Ref: WTJQ26-018

**RE: RESPONSE TO INFORMATION REQUEST – A007001519
42 WELLINGTON STREET MANLY QLD 4179 (LOT 1 & 2 RP73590)**

Response to Information Request

Figure 1. Amended East Elevation (Thinktank Architects)

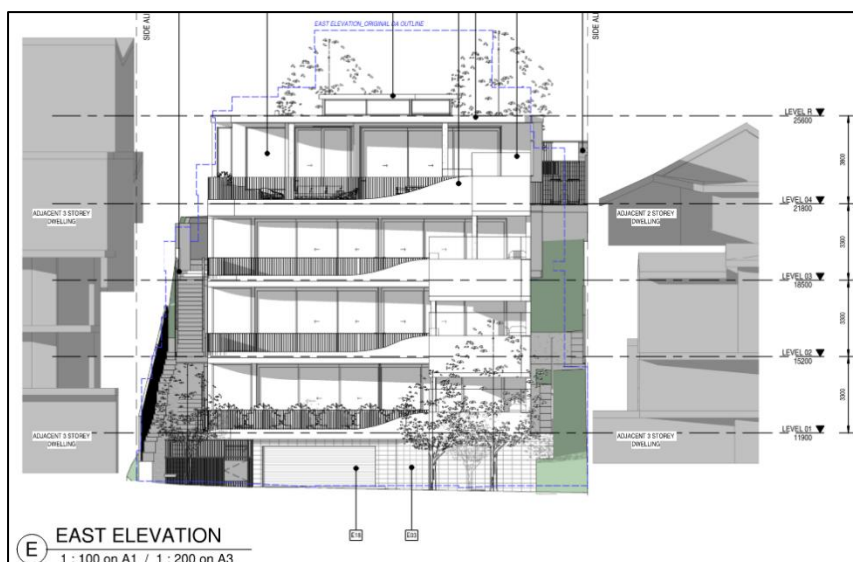
1.1 The proposed development seeks a performance outcome for the number of storeys, overall height, the transition to the adjoining dwelling houses, site cover, and setbacks. To achieve compliance with AO3/PO3 and AO4.1–AO4.2/PO4 of the Multiple dwelling code and OO3(g) of the Wynnum-Manly neighbourhood plan code, amend the plans to include the following:

- Show 'ground level' as defined in City Plan 2014, 1m above ground level and 9.5m above ground on all elevation and section plans.*
- Reduce the overall height to minimise the extent of the building that is above 9.5m above 'ground level'.*
- An improved building height transition to the adjoining dwellings for building elements above 9.5m to achieve a sensitive reduction in building height to the adjoining dwelling houses.*

- d. Clearly identify where the proposed building height does not achieve AO4.1–AO4.2. Provide a visual representation of the proposed versus acceptable height transition outcomes on updated elevation plans.
- e. Amended shadow diagrams showing the shadow cast by a building designed in accordance with all acceptable outcomes versus the shadow cast by the proposed building. Provide the comparison at each time (summer and winter solstice) on the same plan and show the shadows in context with the open space and habitable rooms on adjoining sites.

Please refer to the Amended Architectural Plans prepared by Thinktank Architects (**Attachment A**). The amended design reduces the overall building height and number of storeys, as defined under Schedule 1 – Definitions of City Plan 2014, from 4-storeys to 3-storeys, with a maximum building height of 11.5m.

A performance outcome continues to be sought in respect of the overall building height and height transition to adjoining dwelling houses under AO3/PO3 and AO4.2/PO4, to the extent the amended design does not fully achieve the 9.5m and 2-storey height transition within 10m of the common boundary with an adjoining dwelling house. These performance outcomes are considered to be adequately justified on the following planning grounds, addressed against the specific criteria of PO3 and PO4:

- **PO3(a) – building height is consistent with the intended form and character of the local area including the predominant height of existing or approved buildings in the street:** This design amendment better responds to the Site's topography, presenting as an overall 3-storey interface at the Royal Esplanade frontage, with a reduced 2-storey interface to Wellington Street. This lower-scale presentation is appropriate to the subordinate streetscape and adjoining residential character, which includes a mix of 2 and 3-storey dwellings, which has been referenced with the amended plans. As illustrated below, an outline of the original DA has been superimposed on the amended elevations, resulting in a reduced built form and scale relative to the originally approved design.
